PERFORMANCE BULLETIN

5600 Replacement Timer Motor Caution

Figure 2

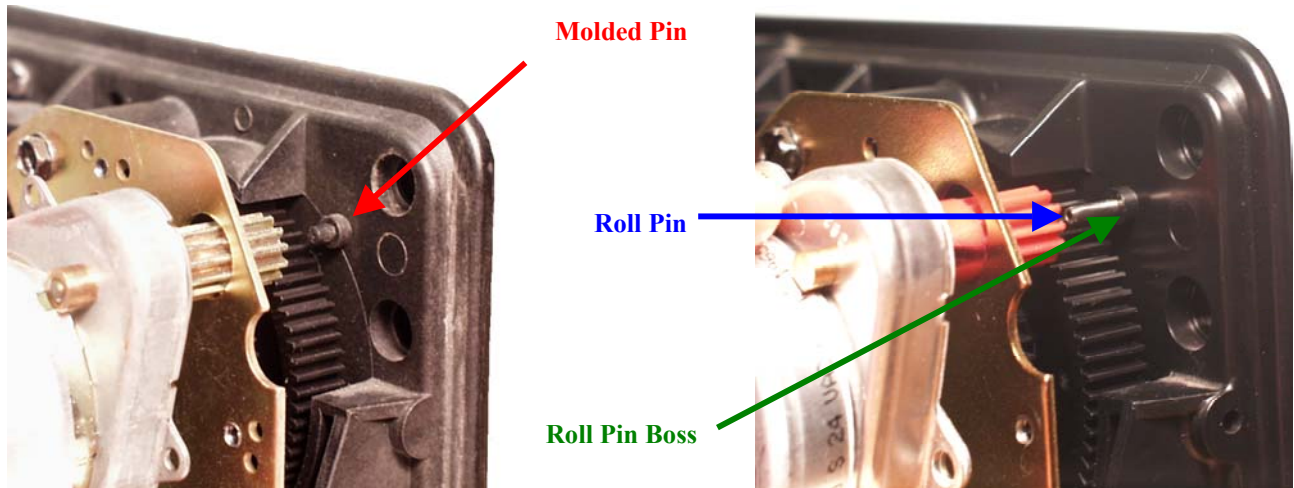
When replacing the drive motor on the 5600-control valve it is important to inspect the housing for the motor support. We have seen motor failures on older standard and "L" style housings due to the following:

Figure 1 The **molded pin** is broken off.

Figure 2 The **roll pin boss** is cracked. In addition, if the **roll pin** has fallen out, there is a strong possibility that the boss is cracked.

Failure to replace the housing under these circumstances may cause the drive motor to fail prematurely.

NOTE: We have added more material to the **roll pin boss** after the dates listed above in figure 2 to help prevent cracking.
